INDEPENDENT CONDITION ASSESSMENT OF THE IRMA STERN MUSEUM

THE FIRS - ROSEBANK
CAPE TOWN

THE IRMA STERN TRUST

DESIGN MATTERS ARCHITECTS

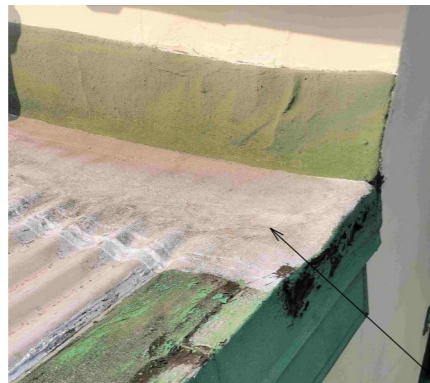
Replace rusted fixings on galvanised roof sheeting

All rotten timbers to be replaced NB structural members as above

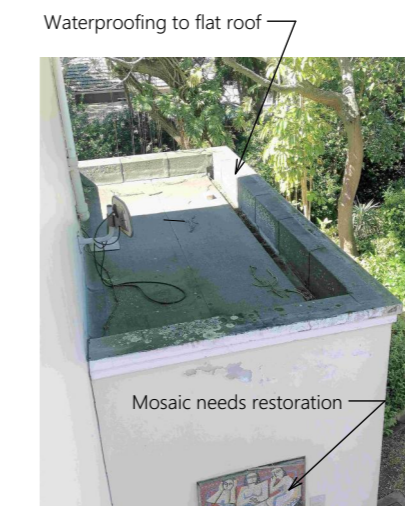
Asbestos roof tiles irreparable

Asbestos roof tiles: all tiles are extremely brittle, curved with fixings coming loose

Eave sprockets, fascias and soffits to be repaired/replaced & painted

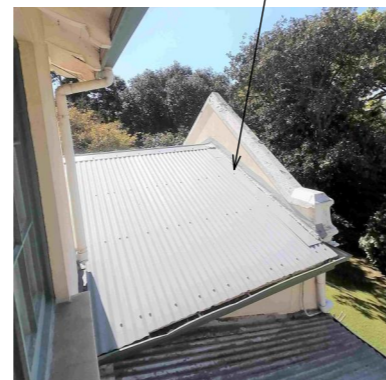
All timber barge boards & fascias require urgent restoration & painting

All roof flashings need to be checked

roof repairs done with mixture of new & old materials- all to be replaced

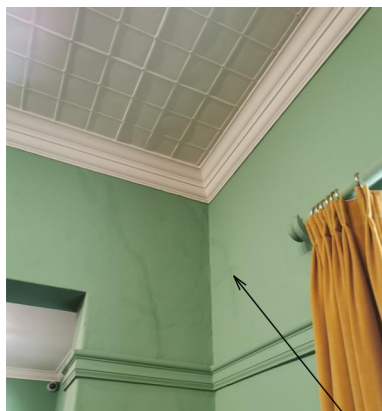
damp to the walls in the outbuildings where the exterior ground levels are too high

Severe structural cracking between gate pillars and coach house and Museum.

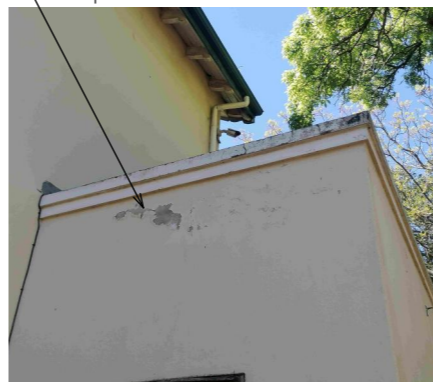
cracks, damaged plaster & poor service installation allowing ingress of water

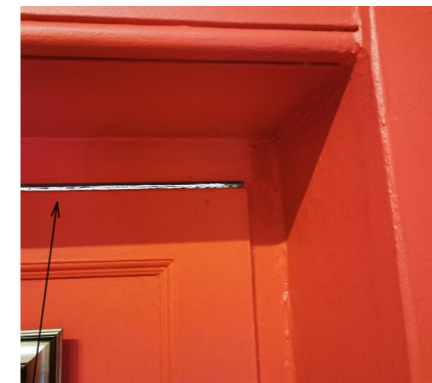
Store 1 door with no doorsill to outside or waterproofing- water free to travel under door to interior

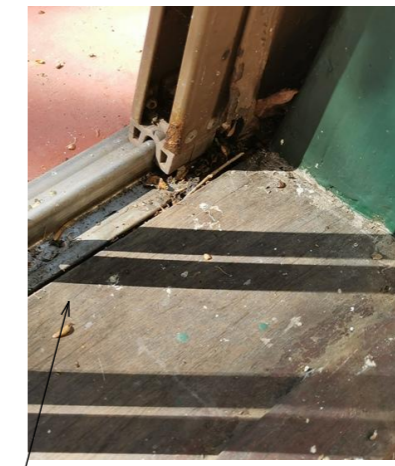
typical inward opening external door (Studio) - no stepped rebate or draft exclusion.

typical inward opening Portrait Room door - Poorly fitting with large gaps all round

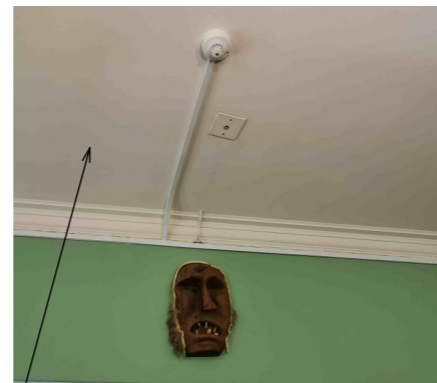
Store 1: Plasterboard ceiling damaged and sagging possibly due to water ingress. Note surface wiring and services!

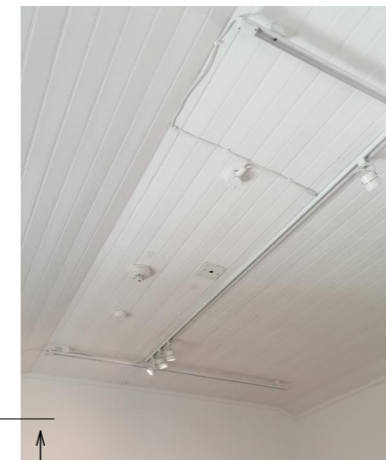
Plasterboard to Lounge - restore previous ceiling or repair with all services hidden

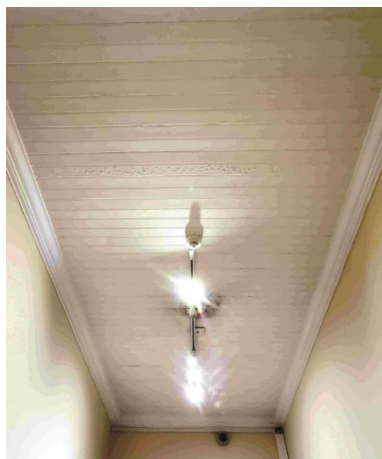
1st Floor - T&G ceilings to be restored & services rationalised

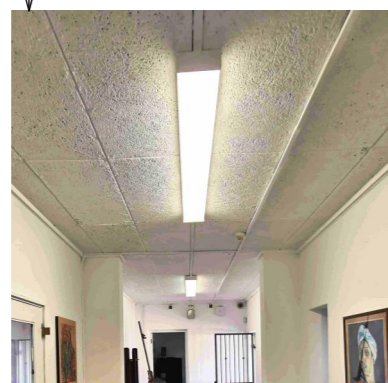
T&G ceiling in passage and stairwell. Original detail lost due to multiple coats of paint

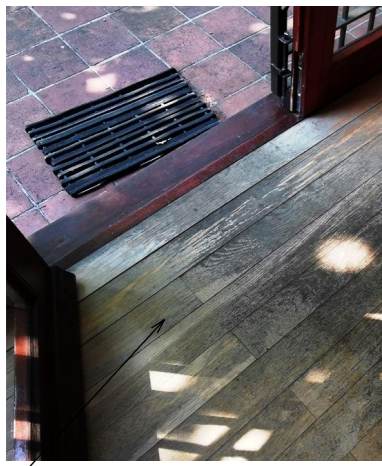
(Dining Room) Embossed wallpaper coming loose, to be restored or replaced to match

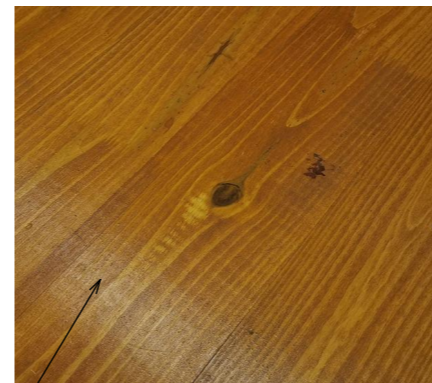
Epoxy floor failing in Store 2 & Kitchen

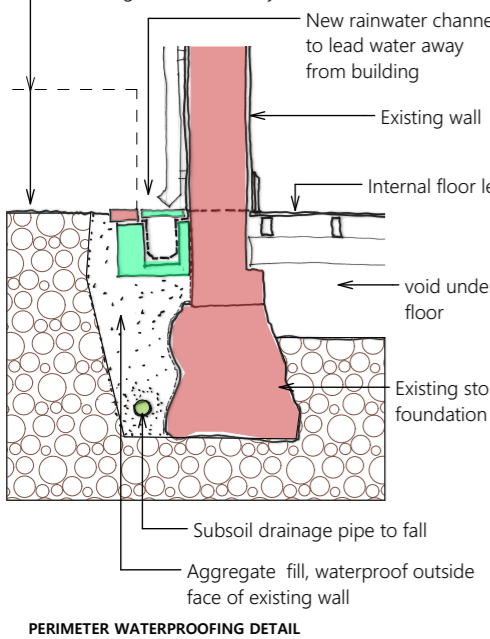
Views of service alley - posing a major risk to flooding of the Museum

Single outlet point in service alley risk of flooding if blocked

PERIMETER WATERPROOFING DETAIL

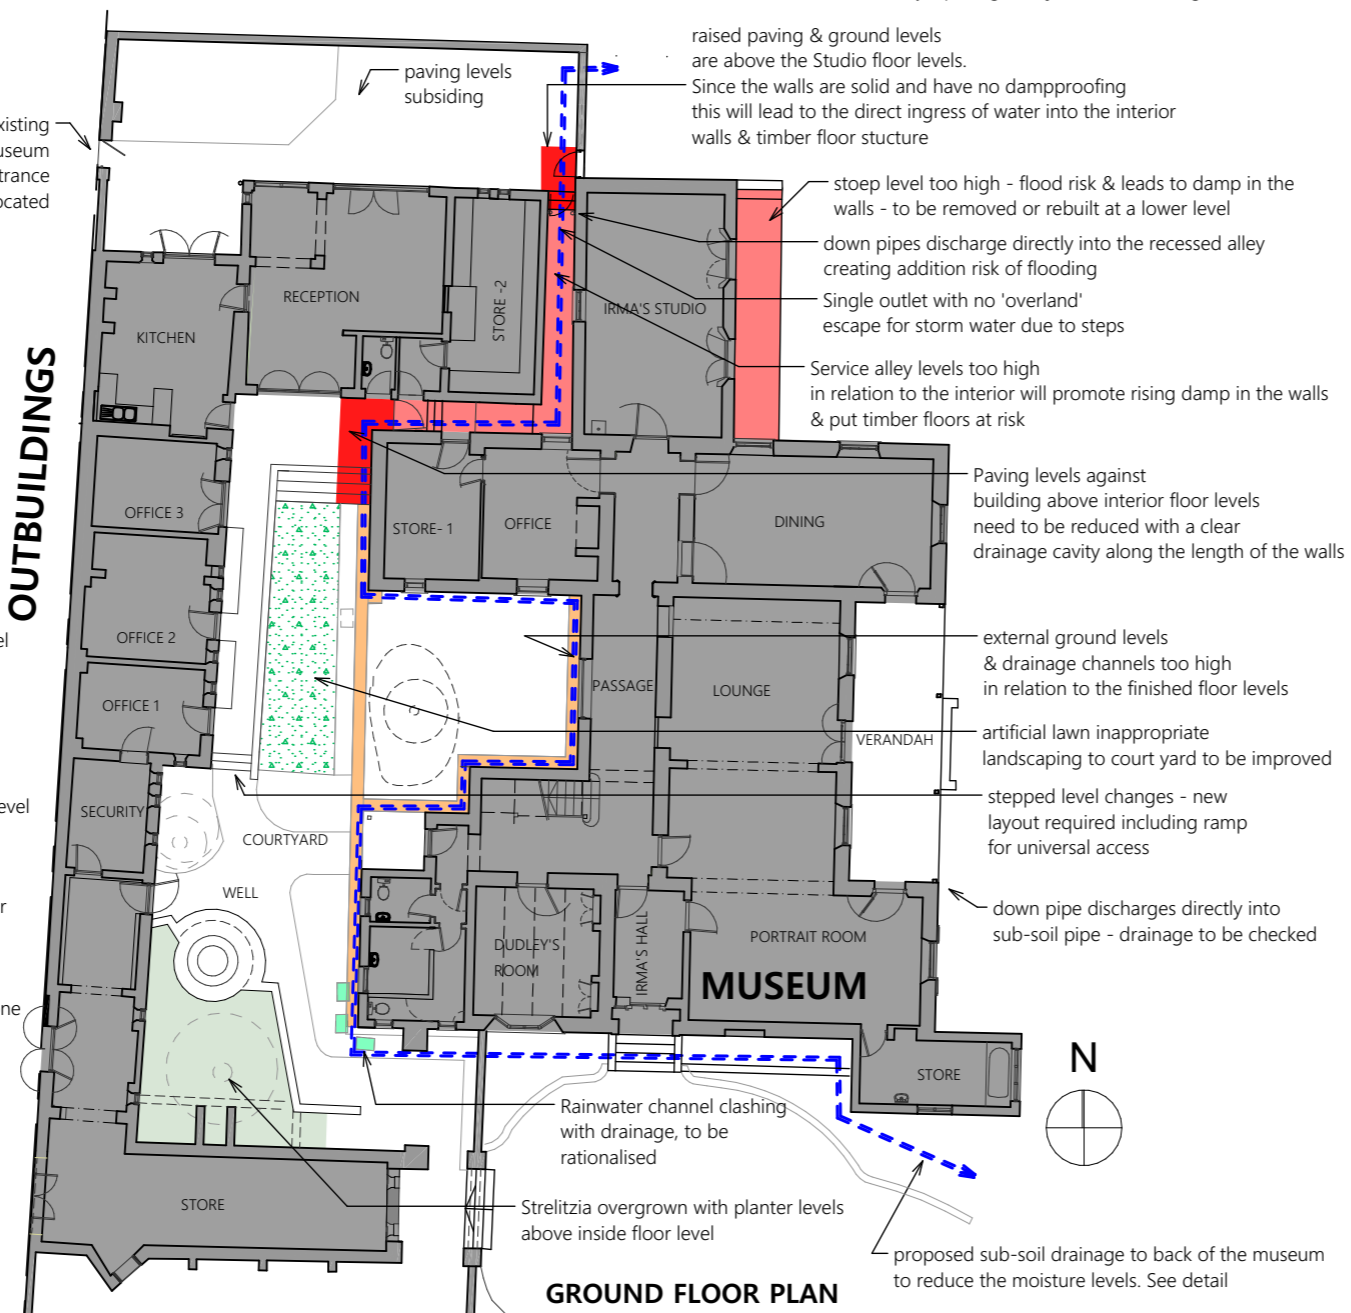
- Rational design required to reticulate groundwater and stormwater away from the Museum.
- See annotated sketch detail suggested to mitigate water ingress to the Museum. New perimeter agricultural drain and storm water channels along Museum external walls (indicated as a double blue hidden line on Plan)
- Redesign the landscaping to the Museum courtyard, restoring the earlier character and patina and providing universal access to all areas.
- Demolish Irma's Studio stoe and rebuild at lower level, min 150mm below internal floor levels.
- Garage door to be upgraded to secure opening.

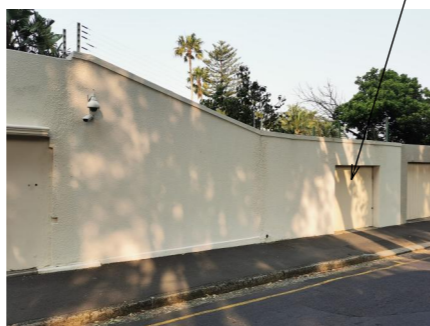
Rainwater channel clashing with drainage.

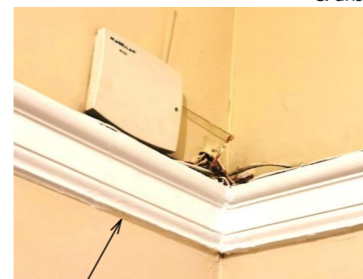
Unsightly surface mounted trunking and exposed wiring.

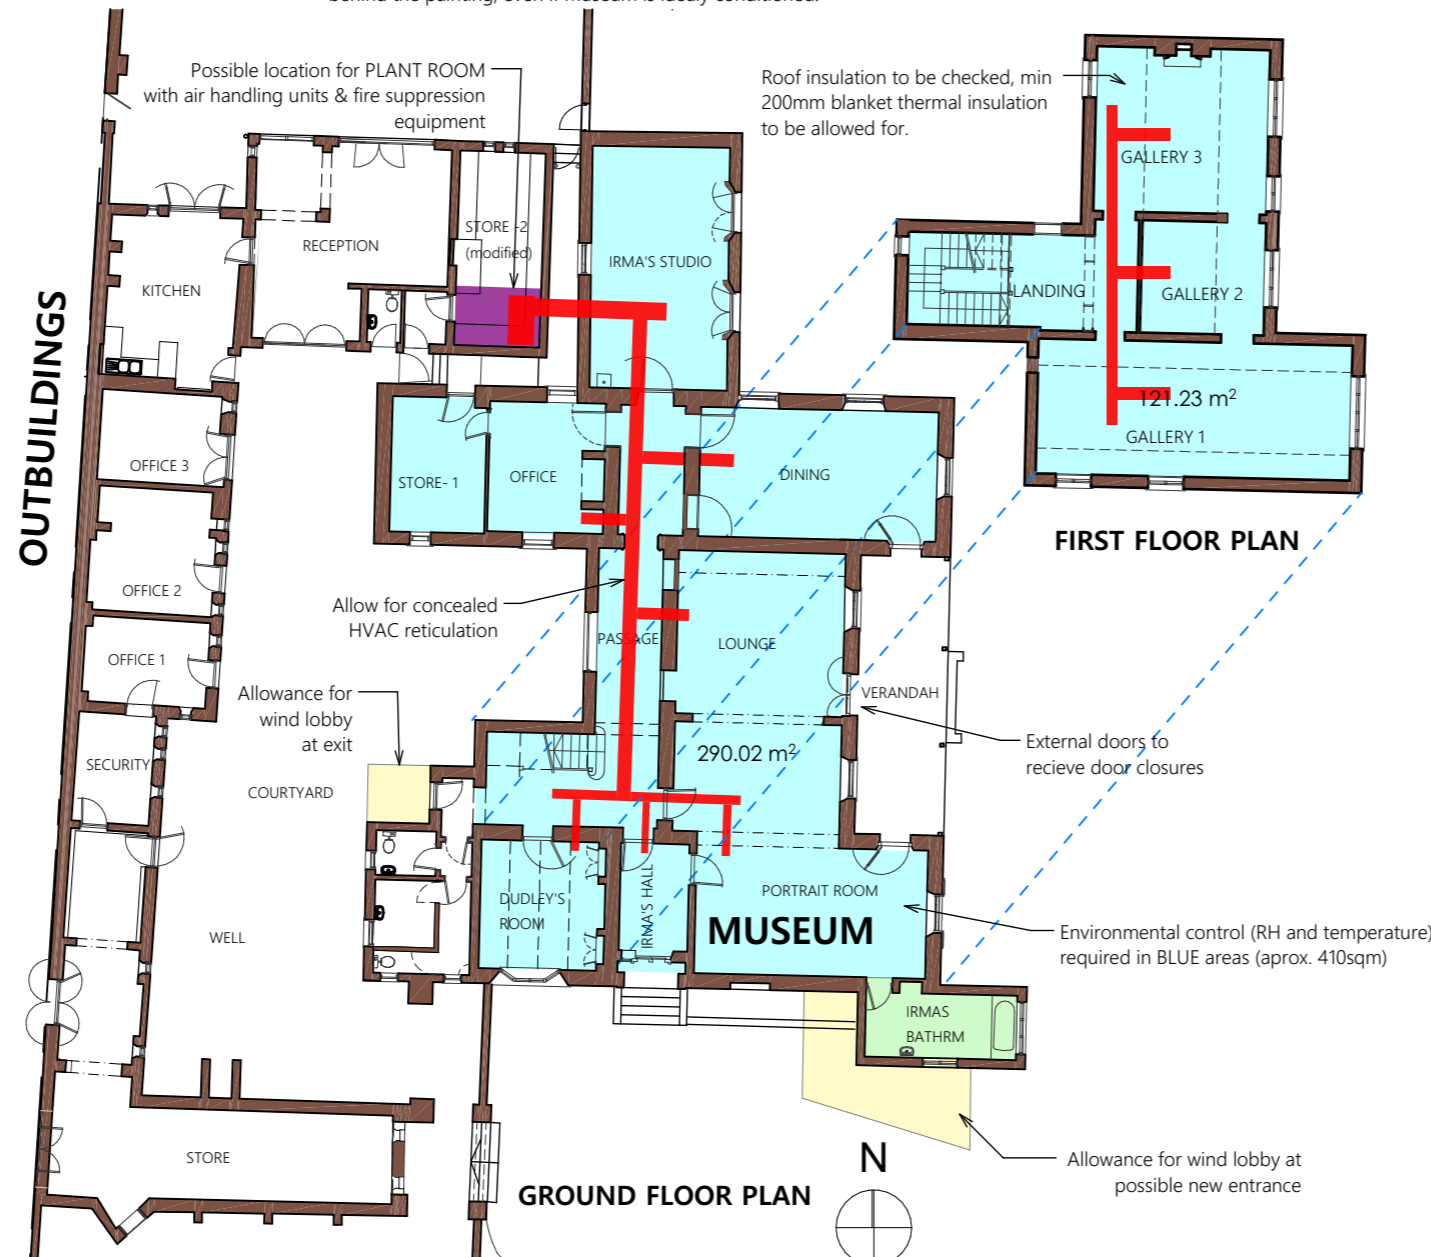
Dehumidifiers installed do not guarantee stable RH and temperature levels.
